AD 50-25-01

Airworthiness Directives; STINSON Model All Model 108 Series Aircraft
PDF Copy (If Available):

50-25-01 STINSON: Applies to All Model 108 Series Aircraft.

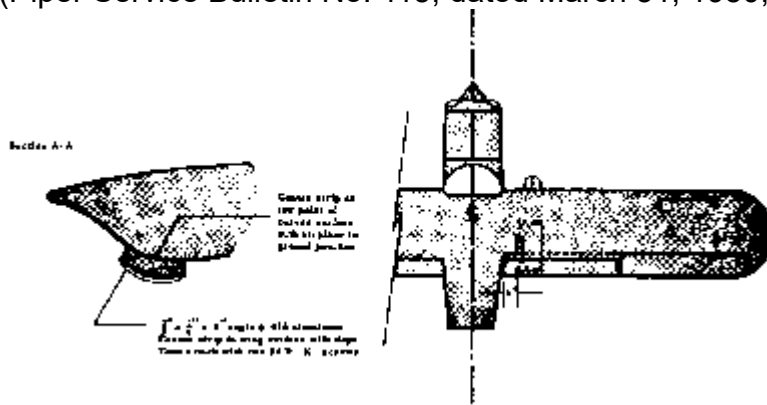
Reports have been received of fuel seepage into the space between the inner cabin trim and the outer fabric covering of the fuselage. This results in soaking of insulating material in the cabin wall. The source of the fuel can be spillage during filling of tanks, thermal expansion of fuel in full tanks, or tank leakage. This fuel runs to the under surface of the wing, adhering to the lower curved surface of the trailing edge of the wing at the flap well, thence inboard to the fuselage and across the rear window. Since the window seal is often not perfectly tight the fuel may then enter the cabin wall.

To preclude the fire hazard of fuel soaked insulation within the cabin wall due to these causes, a drip strip similar to that shown in Figure 1 should be installed on the underside of each wing. This drip strip will prevent fuel from flowing from the wing to the

fuselage.
